Aerospool. Laskusiivekkeiden työntötankojen tarkastus

Koskee: Kaikkia niitä Dynamic WT-9-ultrakevyitä lentokoneita, jotka on varustettu tyypin A laskusiiveketyöntötangoilla..

Subject: Swing bearings and flaps push-rods check

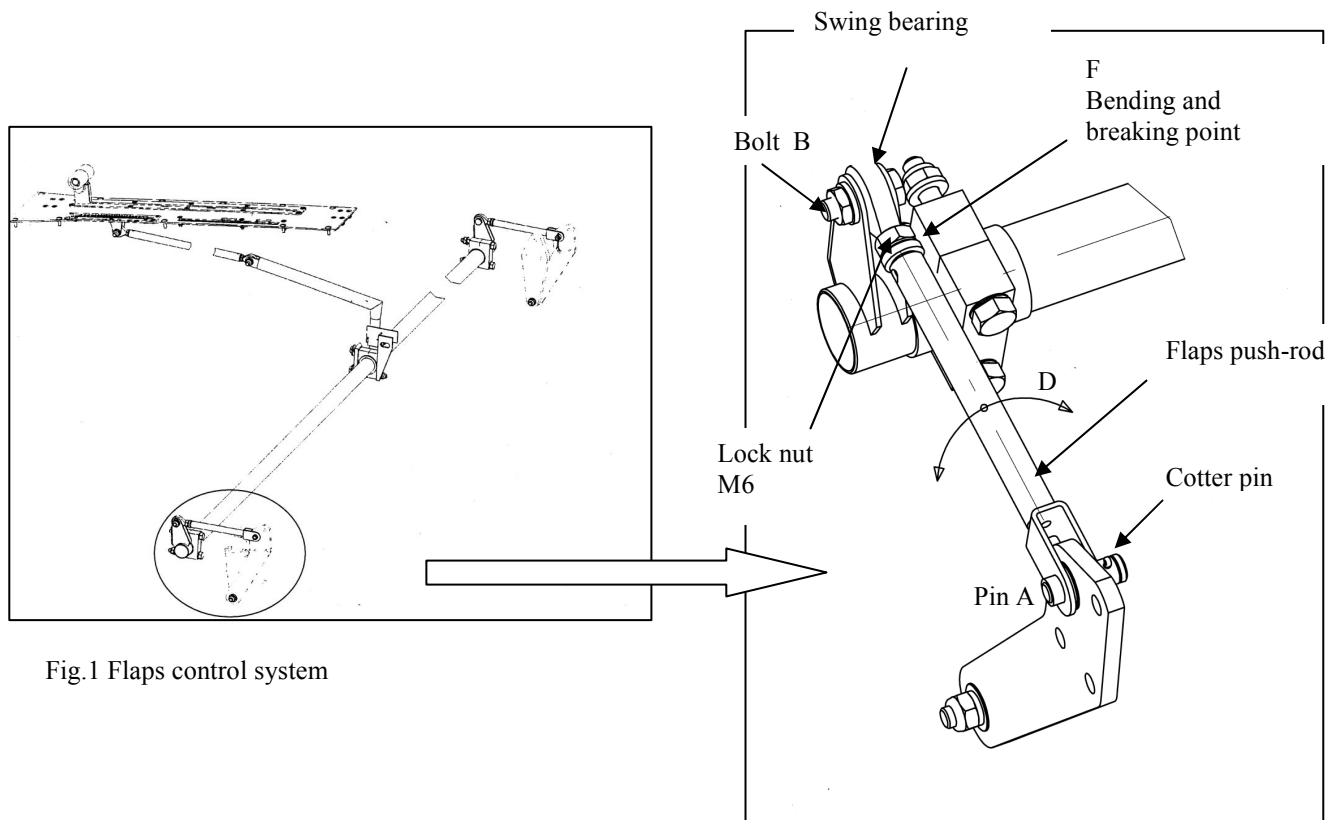
Affected: WT-9 Dynamic, from S/No. DY-002/2001 till S/No. DY-200/2007. Does not apply to aircrafts equipped with flaps push-rod type B (see figure bellow)

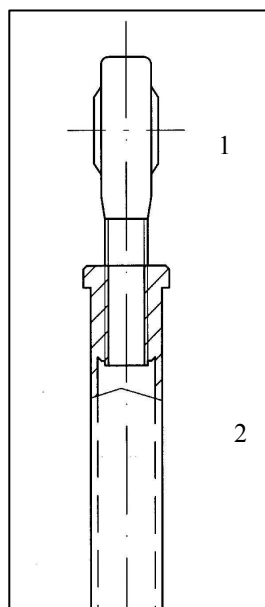
1. Extend the flaps to fully extended position (position flaps 3)
2. Remove the flaps push-rod by following procedure:
 - 2.1 Lock off pin A (remove cotter pin), fig.2
 - 2.2 Put out pin A
 - 2.3 Unscrew the nut of bolt B and put out bolt B
3. Measure and record the total length "d1" on removed flaps push-rod. (see bellow)
Measured value is necessary for reassembly

4. Release the lock nut M6 (fig. 2) and unscrew the swing bearing from flaps push-rod
5. Examine swing bearing (1) and flaps push-rod (2) alignment. Verify if the swing bearing is not bended at point F (see bellow)

6. If the flaps push-rod is in alignment with swing bearing and bending of the swing bearing is not observed, screw swing bearing back to flaps push-rod
7. Set initial distance "d1", measured at I.3
8. Tighten the lock nut M6
9. Mount the flaps push-rod to aircraft in the inverse order as described in I.2
10. Lock pin A by cotter pin
11. Ensure that after flaps push-rod installation there is a free movement of push-rod when flaps retracted and fully extended (fig.2 position D)

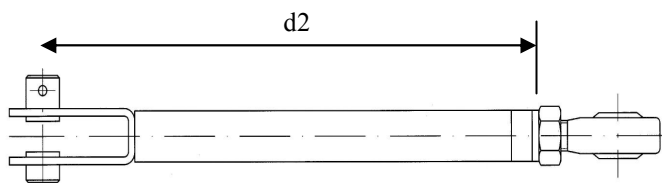
In "Part description box" notice ZBWT9 16A/2012 with length data "d2" for left and right flaps push-rod (data in millimeters)
